Product Change Notification

Change Notification #: 103985 - 01
Change Title: SR1300, PCN 103985-00, FYI, Class 2; 1U Bezel Change
Date of Publication: March 25, 2004

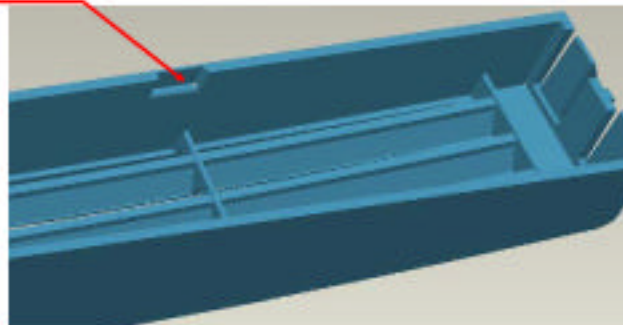
Adding a notch in the inside of the bezel for clearance to the floppy drive eject button for use in future server products. See drawing below for details:

Notch in bezel required for clearance to floppy drive ejector button.
